SURFACE MOUNT COMPONENT SIDE

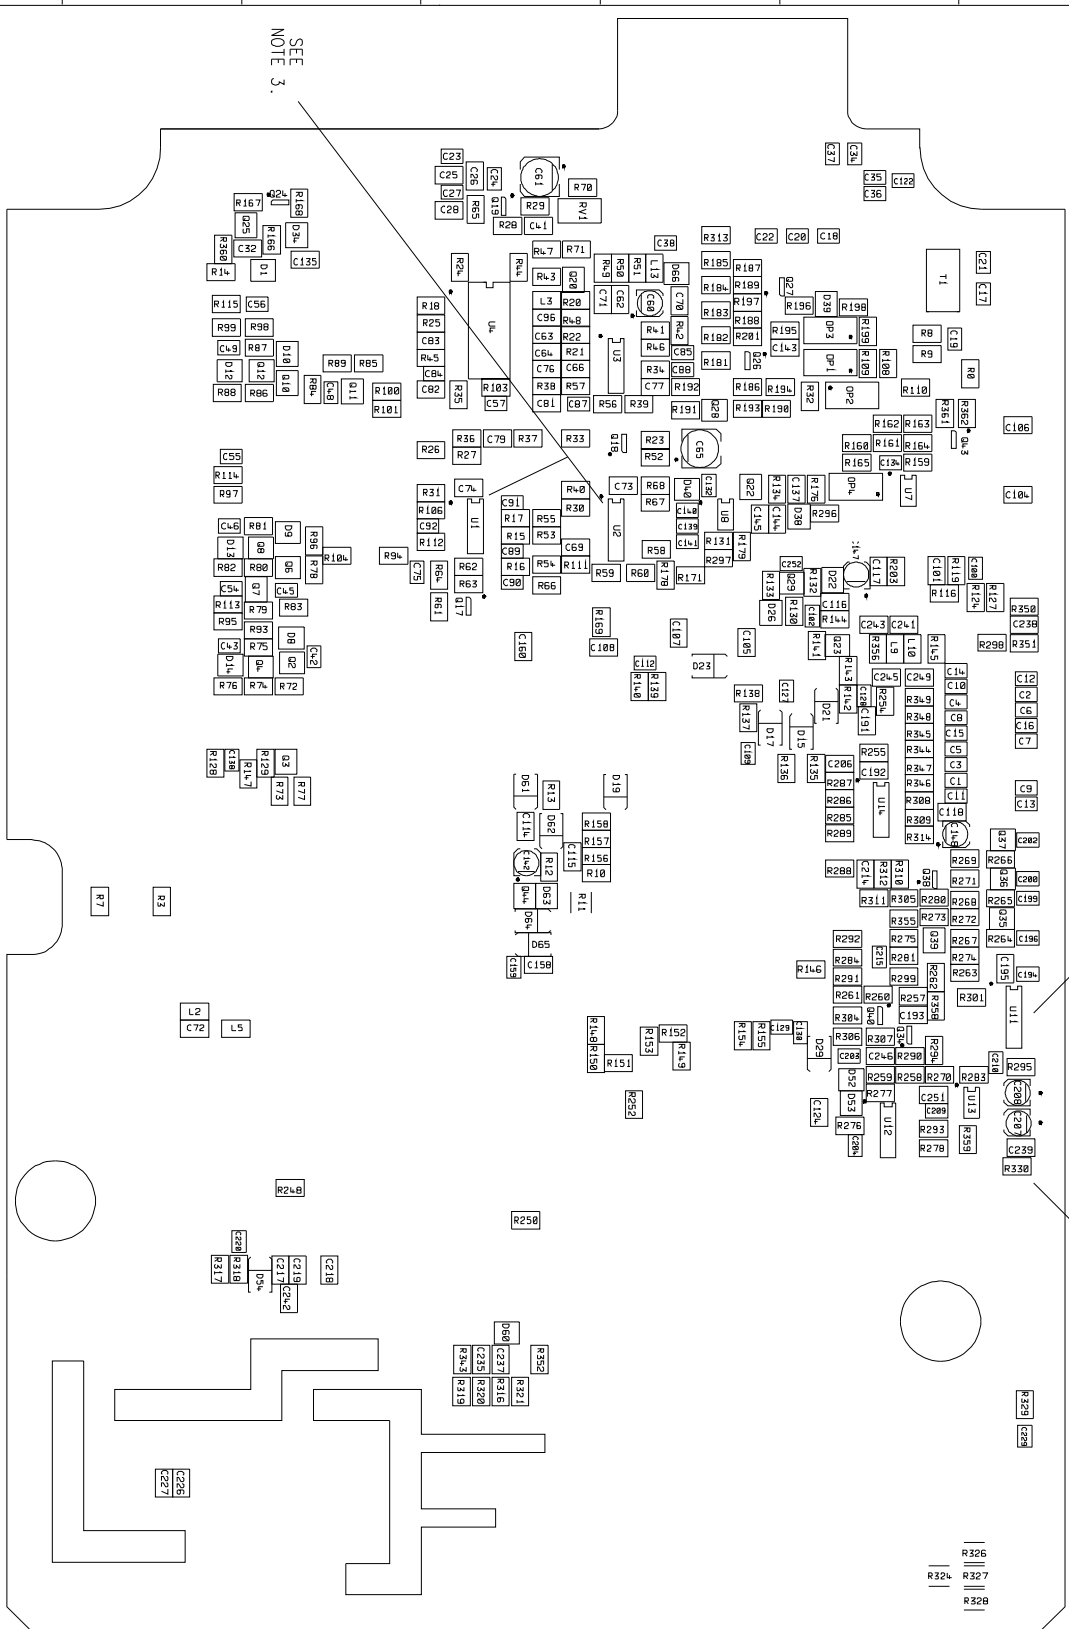
- NOTES:
1. HAND SOLDER C216 ON TOP OF R330.
 2. LIFT U11 PIN 11 & CONNECT TO PIN2 USING SLEEVED LINK WIRE AS SHOWN BELOW:

- 3a. CUT TRACK BETWEEN U1 PIN 6 & U2 PIN 2 ON COMPONENT UNDERSIDE, THEN HAND SOLDER R117 ACROSS THE CUT TRACKS AS SHOWN BELOW:

CUT TRACK

SOLDER R117
ON TO PADS

- 3b. HAND SOLDER C80 ACROSS U2 PINS
1 & 2 AS SHOWN BELOW:
